Metro North-West Joint Development Assessment Panel Agenda

Meeting Date and Time: 1 April 2020; 09:00am
Meeting Number: MNWJDAP/283
Meeting Venue: This meeting is available for members of the public to attend via teleconference.

DAP Name:	Metro North-West JDAP
Local Government Area:	City of Stirling
Applicant:	Urbis Pty Ltd
Owner:	ALDI Foods Pty Ltd
Value of Development:	\$4.5 million <input type="checkbox"/> Mandatory (Regulation 5) <input checked="" type="checkbox"/> Opt In (Regulation 6)
Responsible Authority:	City of Stirling
Authorising Officer:	Stevan Rodic, Acting Director Planning and Development
LG Reference:	DA19/1926
DAP File No:	DAP/19/01711
Application Received Date:	9 December 2019
Report Due Date:	20 March 2020
Application Statutory Process Timeframe:	90 Days
Attachments:	<ol style="list-style-type: none"> 1. Development plans date stamped 20 December 2019 and 28 February 2020 2. Aerial Location Plan 3. Metropolitan Region Scheme Zoning Map 4. City of Stirling Local Planning Scheme Zoning Map 5. Turning movement diagrams date stamped 28 February 2020 6. Applicants Response to City's Design Review Panel held 23 January 2020 received 28 February 2020 7. Applicants re

t16.099B.sk30c
27/02/2020
Scale: 1:400 @ A3

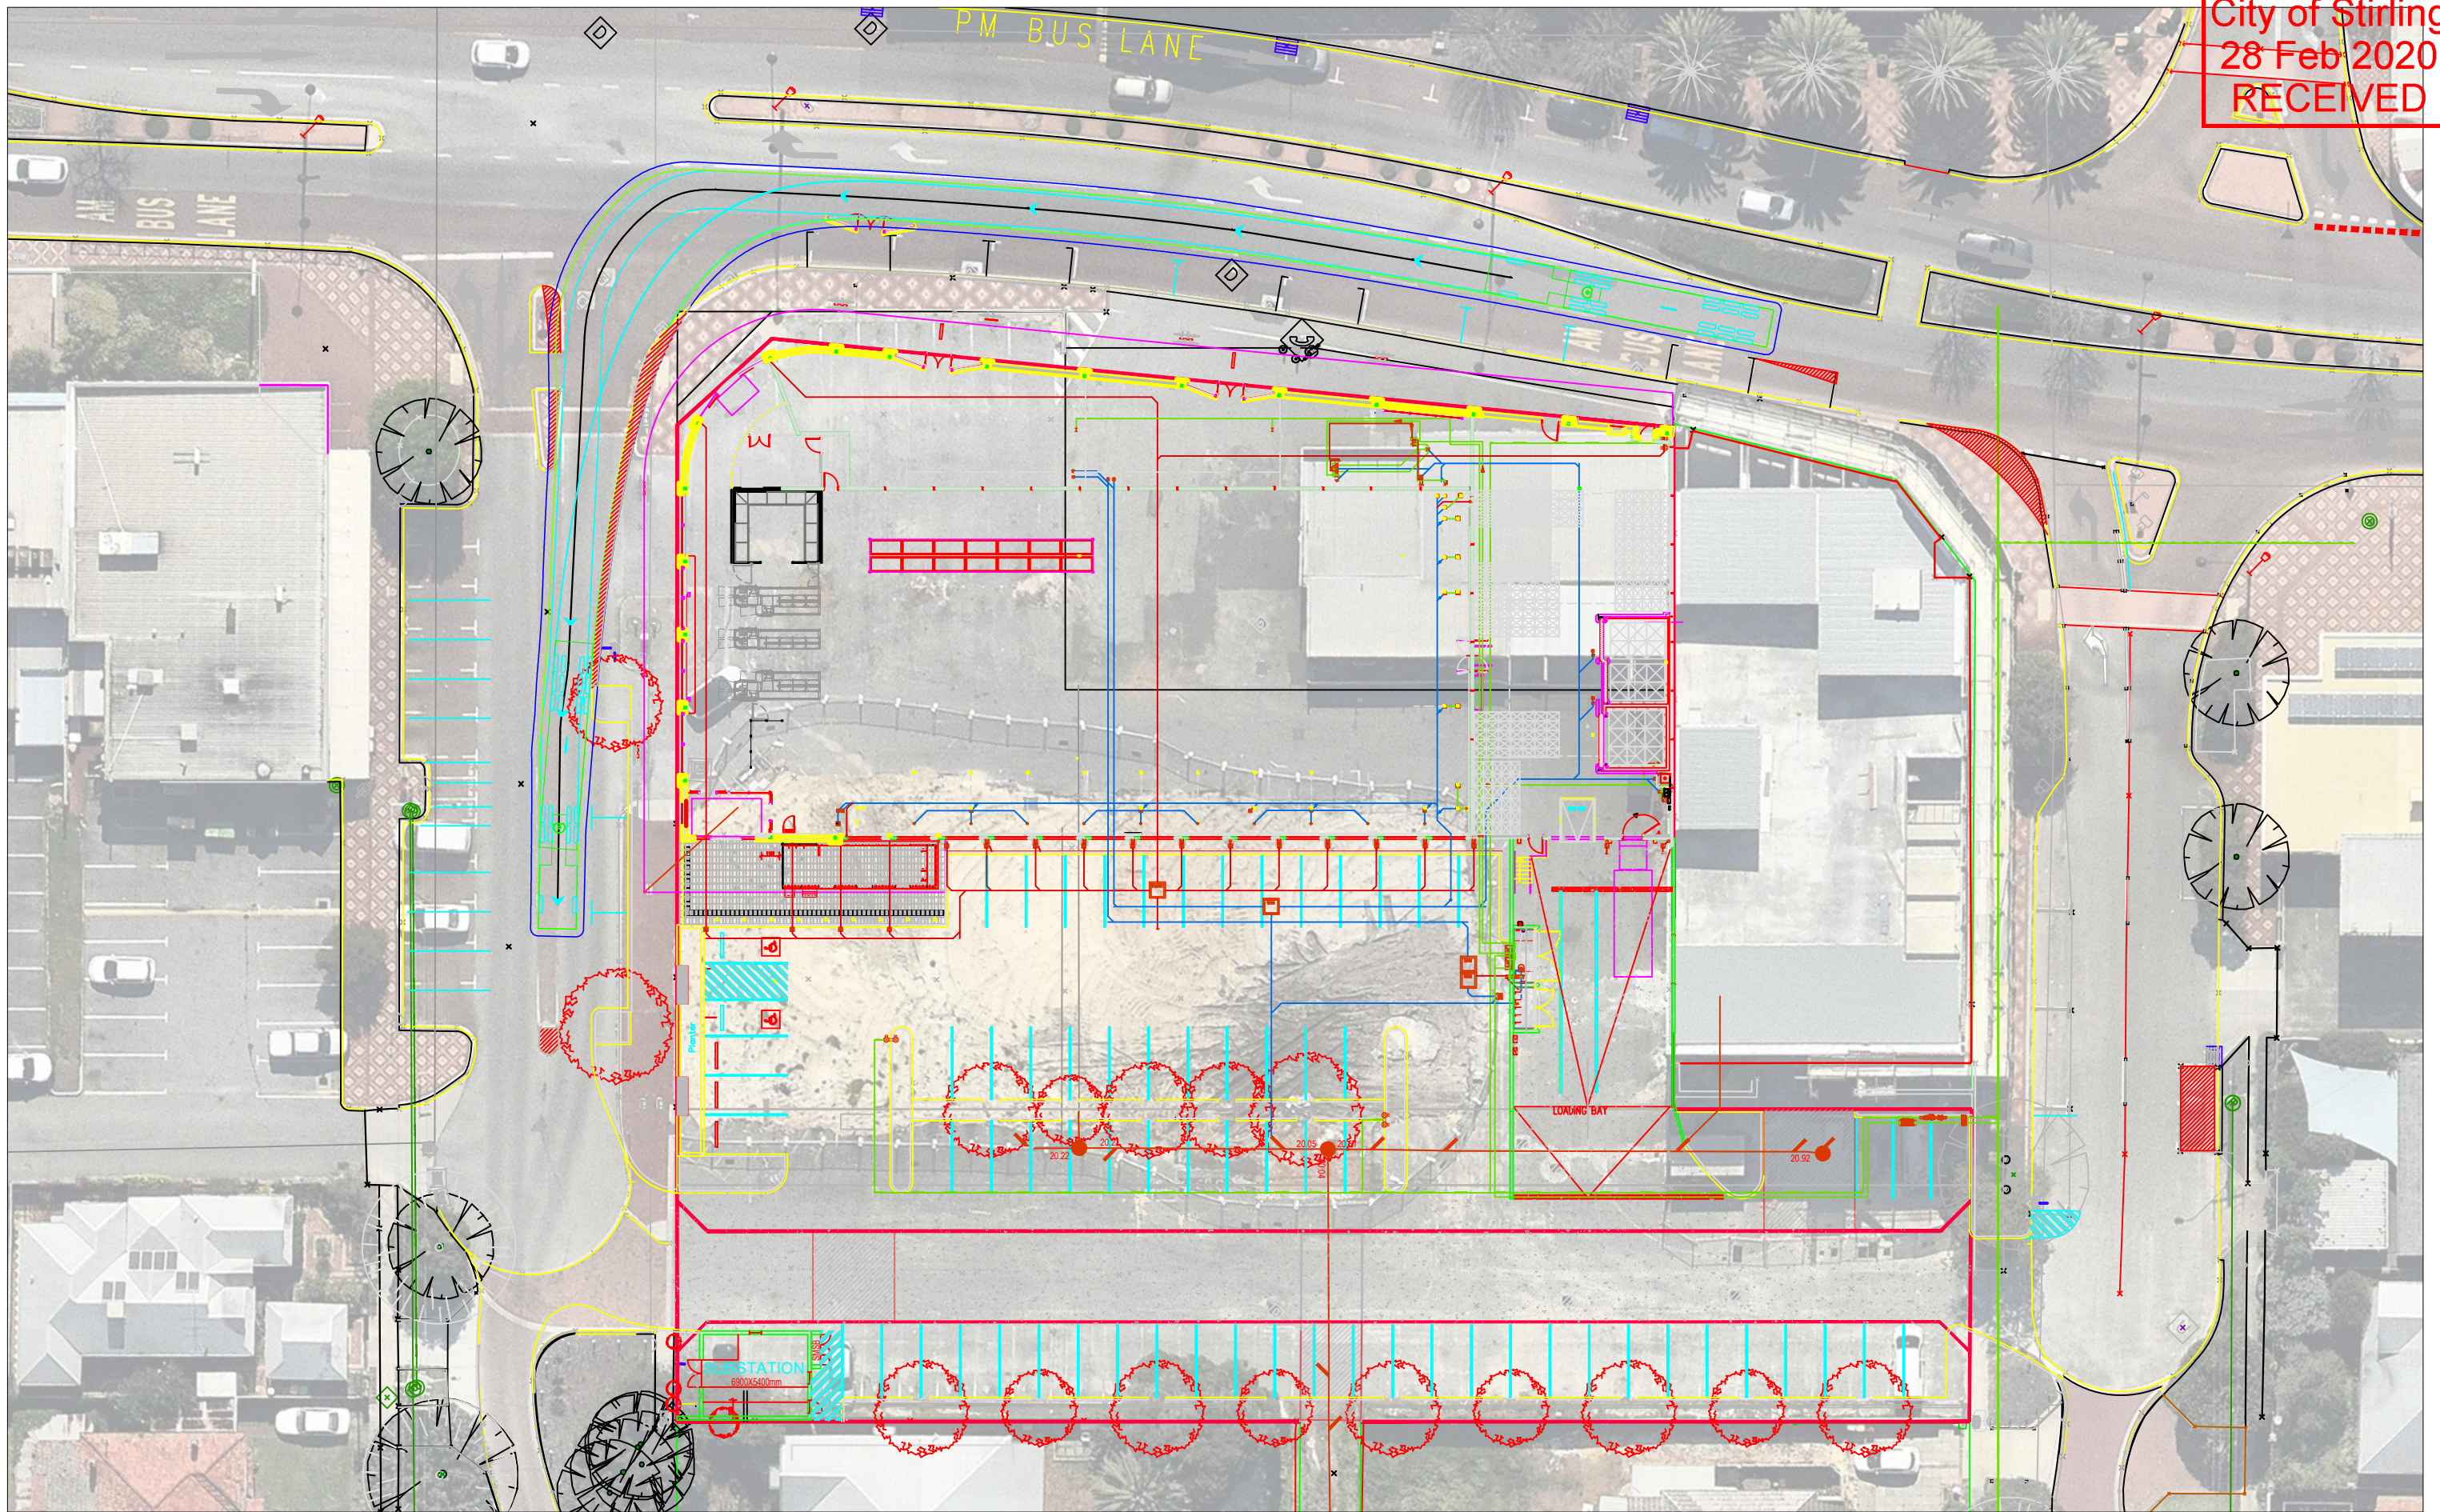
- Provides an assessment of the proposed development access points;
 - Models the site utilising the current traffic data;
 - The 19.0m Semi-trailer Truck Circulation Diagrams t16.099B.sk29d and t16.099B.sk30c are to remove the requirement for modification to the existing Beaufort Street/Tenth Avenue and Beaufort Street/Eleventh Avenue intersections;

UNDERCROFT
FLOOR PLAN
SCALE 1:100

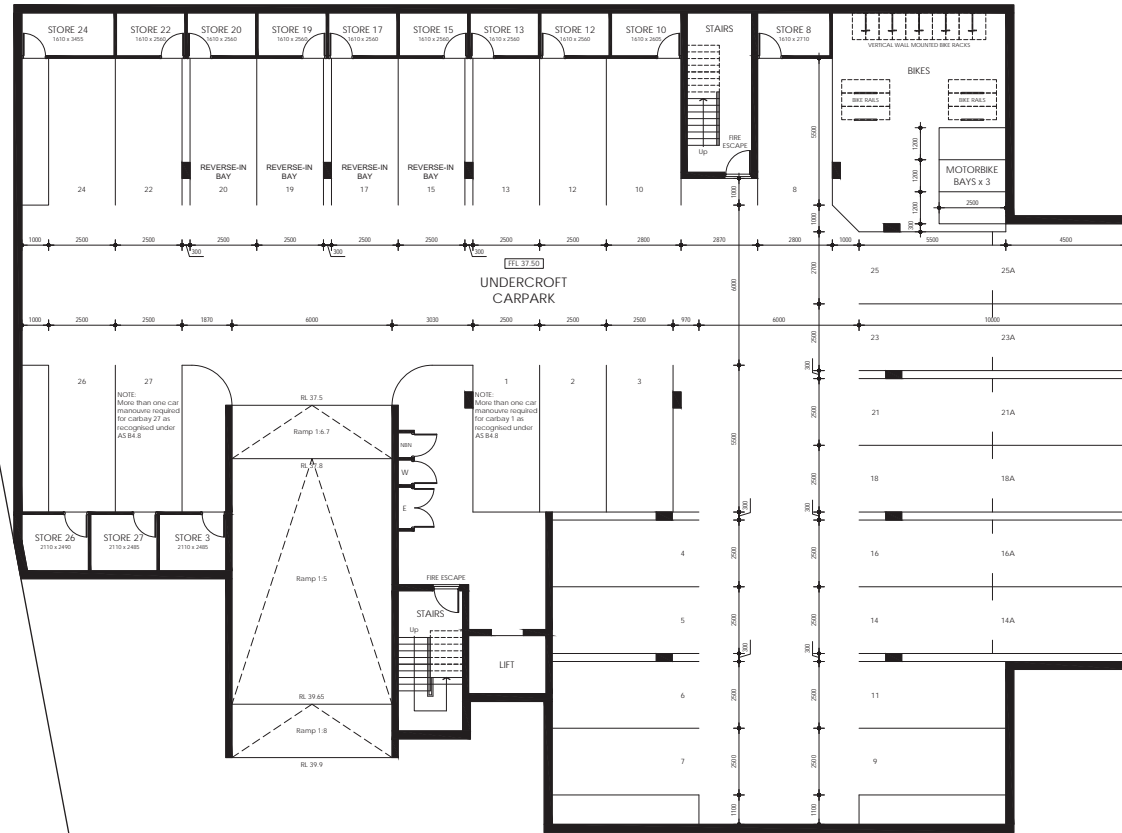
Building Services
City of Joondalup Comment: Details of car parking bays and accessible bays needs to be provided in accordance with Part D3.5 of the NCC-BCA. An accessible car bay is required given an accessible toilet is provided on the ground floor and there is an area of communal open space.
Applicant Response: Our Building Survey has advised that an accessible car bay is not required for the Class 2 development, in accordance with Part D3.5.
City of Joondalup Comment: Two fire exits are required from the basement car parking area with the exit door(s) required to open in the direction of travel. The front door and access gates on the Ground Floor are required to open in the direction of travel. Confirmation that the rear fire exit leads to open space and finally to the road is required.
Applicant Response: Please refer to the revised plans which demonstrate two emergency exits from the basement car parking area. The doors have been amended to swing in the direction of egress. The rear fire exit leads to the parking area of the adjoining community centre. A performance-based solution will be developed by the appointed Fire Engineer at building permit stage.

<p>City of Joondalup Comment:</p> <p>There are inconsistencies in terms of levels on the site plans at the top of the ramp leading to the underground parking area. DWG SK02 – Undercroft Floor Plan indicates that the level before the ramp leading down is 40.0, whilst DWG SK03 – Ground Floor Plan has the level as 39.90. Applicant to review and amend accordingly.</p>
<p>Applicant Response:</p> <p>Please refer to the revised drawings. Consistent levels have been documented on all drawings.</p>
<p>City of Joondalup Comment:</p> <p>The applicant needs to review the proposed entry to the lot and how that interacts with the road reserve and surrounding infrastructure (i.e. will a defined crossover be provided).</p>
<p>Applicant Response:</p> <p>The proposed development utilises the existing 8.5m wide crossover from Glenelg Place. The crossover width provides adequate manoeuvring area for waste vehicles to leave the site in a forward gear and exit onto Country Club Boulevard.</p> <p>The internal driveway will be delineated from the waste collection area through the use of different surface materials. This will provide a defined driveway with direct connection from the street to the undercroft parking area. In addition, the proposed footpaths along the Glenelg Place road reserve assist to further define the existing crossover.</p>

<p>Applicant Response: All car bays are compliant with AS2890.1:2004.</p> <p>We are not aware of any requirements of AS2890.1:2004 where car bays 15, 17, 19 and 20 are required to be 'reverse-in only' bays. Please elaborate.</p> <p>Car bays 26 and 27 can have multiple turns when entering or exiting the development, in accordance with Clause B4.8 of AS2890.1:2004.</p>
